**STATE OF MINNESOTA**  
**BEFORE THE PUBLIC UTILITIES COMMISSION**

*In the Matter of Minnesota Power's  
Application for Approval of its 2021-  
2035 Integrated Resource Plan*

**PUC Docket No. E015/RP-21-33**

**CLEAN ENERGY ORGANIZATIONS'**  
**REPLY COMMENTS**

**Figure 2. Natural Gas futures prices since 2008<sup>63</sup>**

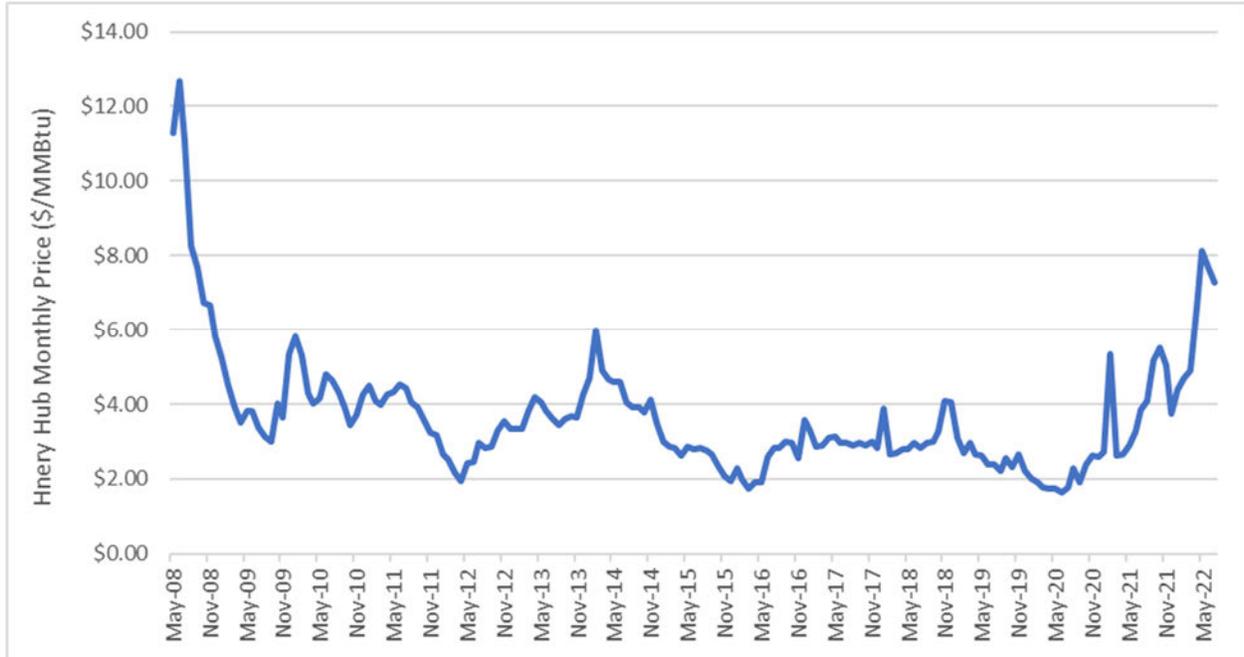
quarter of 2022.<sup>61</sup> In May of this year, monthly Henry Hub natural gas prices rose to a 14-year high, at \$8.14/MMBtu, with prices having nearly tripled from the previous year.<sup>62</sup>

By contrast, in this IRP Minnesota Power is forecasting gas prices ranging from \$3.42/MMBtu in 2021 rising to \$4.84/MMBtu in 2035.<sup>64</sup> In its *EnergyForward* filing, through which it sought and obtained approval of NTEC, Minnesota Power was even more optimistic about low and stable future gas prices. When MP discussed the risk factors the NTEC project faced, it said this about gas price risk: “With natural gas prices currently ranging between \$2.50/MMBtu and \$3.00/MMBtu and likely to remain lower than historical values for the foreseeable future, and given the availability of diverse natural gas supply options, the risks related to natural gas pricing
